Access Compliance Report

Public Rights-of-Way

Intersection ID: 6838	Main Street: OLD_PLANK_RD	Cross Street: MARGARET_TURNER_RD	Location: NW
ADA ID: D441C38ECE46	Ramp Type: Perp	Initial Pass/Fail: Fail	Overall Compliance: No
			Severity Score: 26.25

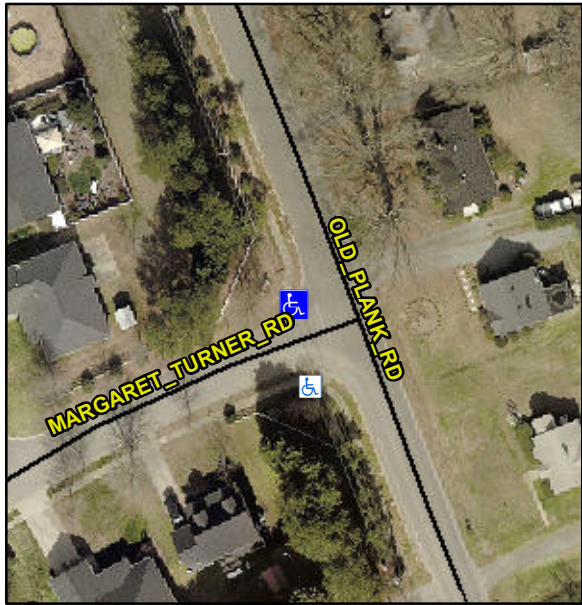
Codes/Mitigation Info/Possible Solution			Field Measurements/Component Compliance					
	Possible Solutions:		Compliance	Description	Data	Compliance	Description	Data
	Remove & Replace Entire Ramp.		N/A	Ramp Length (in)	51.0	No	Ramp Slope (%)	15.2
			Yes	Ramp Width (in)	86.5	No	Ramp XSlope (%)	2.4
			N/A	Flare Type LT	N/A	N/A	Flare Type RT	N/A
			N/A	Flare Slope LT (%)	N/A	N/A	Flare Slope RT (%)	N/A
			N/A	Flare Traversable LT?	N/A	N/A	Flare Traversable RT?	N/A
			N/A	Landing Length (in)	N/A	N/A	DWS Provided?	N/A
			N/A	Landing Width (in)	N/A	N/A	DWS Contrast?	N/A
			N/A	Landing Slope (%)	N/A	N/A	DWS Length (in)	N/A
			N/A	Landing X Slope (%)	N/A	N/A	DWS Full Width?	N/A
Surveyor Notes:		N/A	N/A	Landing Curb? (Y/N)	N/A	N/A	DWS Offset (in)	N/A
PROW/ADA:		Not Found, R304.2.2, R304.5.3	N/A	Shared Landing?	N/A			
			N/A	Gutter Ponding?	Yes	N/A	Gutter Slope (%)	N/A
			N/A	Gutter Lip Ht (in)	N/A	N/A	Gutter X Slope (%)	N/A
